SERVICE BULLETIN

SPECIAL INSPECTION TO INCREASE THE TBO FOR ROTAX® ENGINE TYPE 912 A (SERIES) SB-912-005 R3

Fig. 1
Friction washer

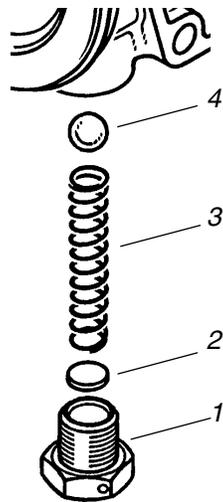
If hex. nut is still secured by a lock washer, it has to be exchanged for the friction washer (1) according to current Maintenance Manual (Heavy Maintenance).

Fig. 2
Improved oil pressure control

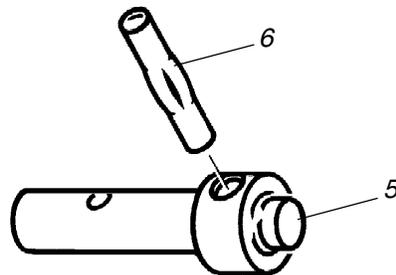
From engine S/N 4,005.186 onwards, to improve oil pressure control the following parameters of the relief valve were changed. Free length of the compression spring (3) was reduced from 46 mm (1.81 in.) to 39 mm (1.55 in.). Spring rate was changed by increase of wire dia. from 0,8 mm (.031 in.) to 0,9 mm (.035 in.), and dia. of ball was increased from 8 mm (.31 in.) to 8,5 mm (.33 in.). If existing, remove shim (4), but if specified oil pressure can't be reached, adjust pressure by adding shim again.

◆ NOTE: Starting with engine S/N 3,792.944 the oil pump housing and oil pump cover is in pressure die cast. On this occasion capacity of the pump was increased by lengthening of the rotary piston assy. from 13 mm (.51 in.) to 16 mm (.63 in.) along with the respective changes of oil pump housing, pump shaft and O-rings.

From engine S/N 4,076.068 onward the follower in the oil pump shaft (6) was changed to notched pin (5) instead of the former dowel tube.

At a renewal of components change oil pump to the version with the 16 mm (.63 in.) long rotors.

Fig. 4
Water pump

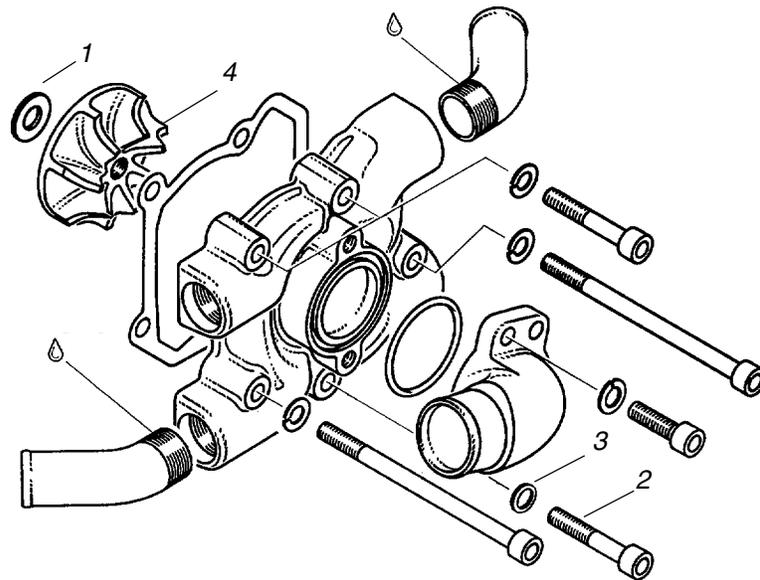
Operation of the engine without antifreeze in the coolant is not permitted since increased formation of corrosion. Therefore the material of the pump shaft was changed with engine S/N 4,076.122. Because of galvanic reactions, caused by the use of various materials, the washer (1) and the screw (2) are of stainless steel since engine S/N 4,076.178.

Fig. 5
Check of float chamber

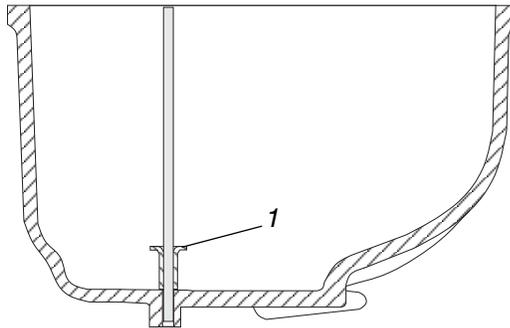
Remove float chamber and lift out both floats. If float chamber is still without distance pieces (1), part no. 861920, add them now, thus avoiding possible sticking of the floats in the float chamber.

Fig. 6
Check of float

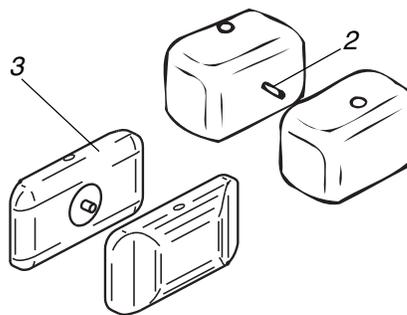
Check support pin (2) of floats. At heavy wear of float bracket contact faces, caused by excessive vibration, exchange these floats to floats of modified shape (3), part no. 861183 as per amendment no. 37-01 and re-new float bracket as required.
